# CLA Engineers, Inc.

May 26, 2021

RE: Benz Street Solar Project  
31 Benz Street, Ansonia, CT  
CLA-6430  
Updated Project Plan & Drainage Report

# BENZ STREET SOLAR CONNECTICUT SITING COUNCIL DOCUMENTS

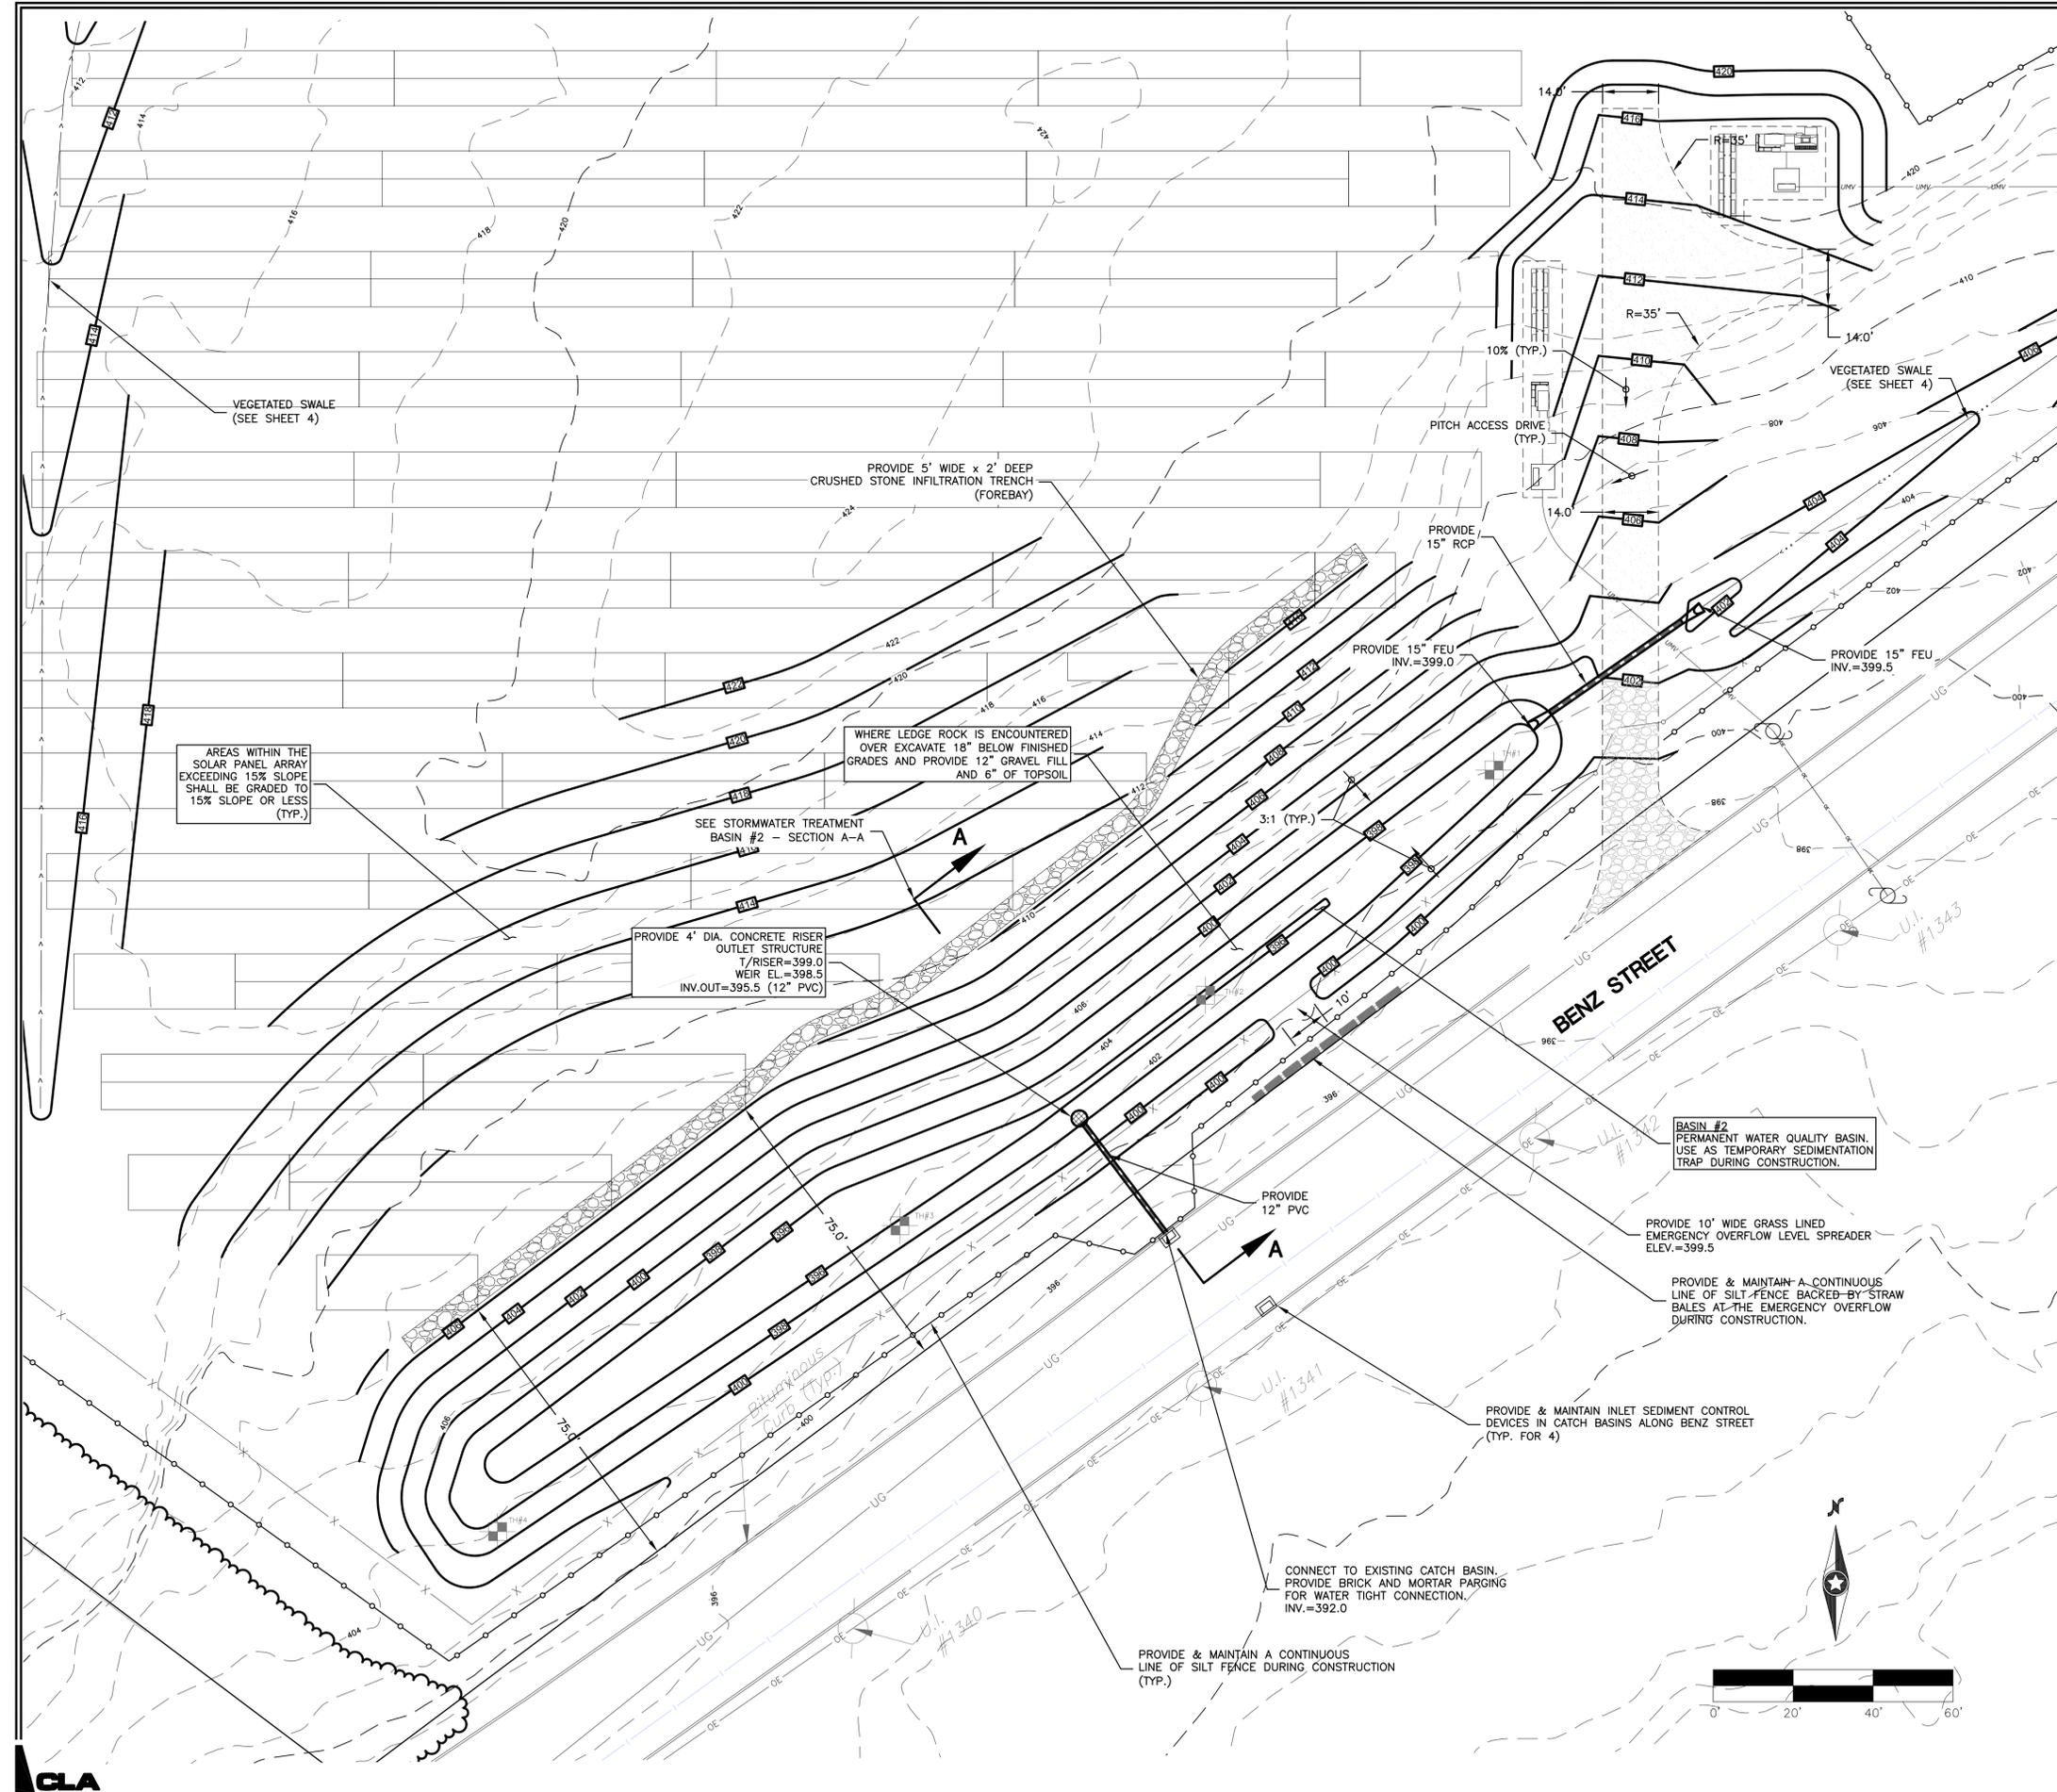
3. Site grading has been proposed to eliminate the steep slopes on site and allow for a maximum slope of 15%. See plan sheets 4-6.
4. Provisions for rock and ledge management and stabilization are included on plan sheet 10.

5. Additional test pits were performed within Basin #1. Test pit logs are included on plan sheet 4.
6. Permeability tests were run for the soil samples taken from Basin #1 and Basin #2. The permeability was found to be 3.13 ft/day in Basin #1 and 2.32 ft/day in Basin #2. The data is included in the Drainage Report Appendix A.

**STORMWATER TREATMENT BASIN #2 - SECTION A-A**  
SCALE: HORIZ: 1"=20'  
VERT: 1"=2'

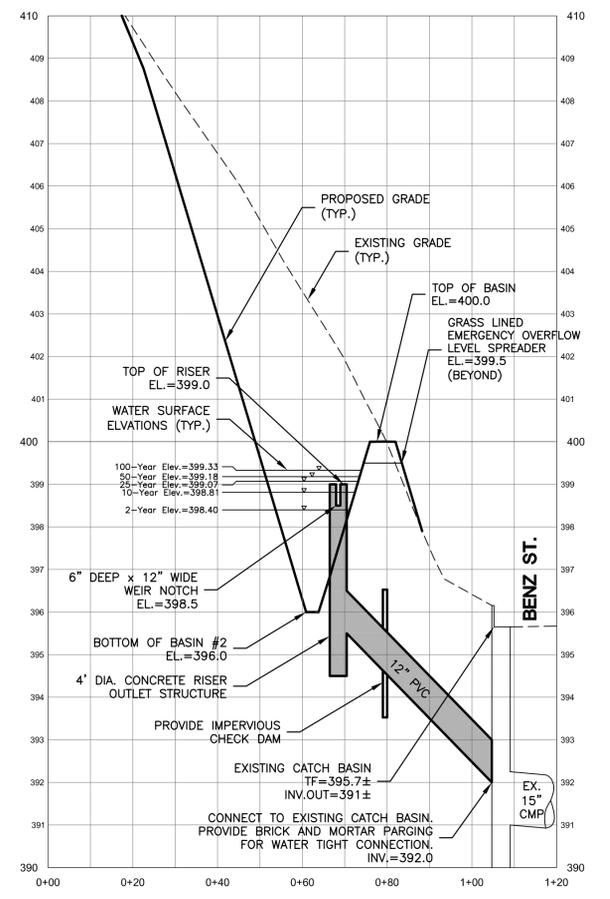
- B. Basin #2 has been designed as an “infiltration basin”. The site soil profile and characteristics support this type of basin. A forebay has been included upgrade of

the basin that will store more than 25% of the required water quality volume as recommended in the Water Quality Manual for this type of basin. The plan for the basin is included on plan sheet 6, and a narrative is included in the Drainage Report, page 9.
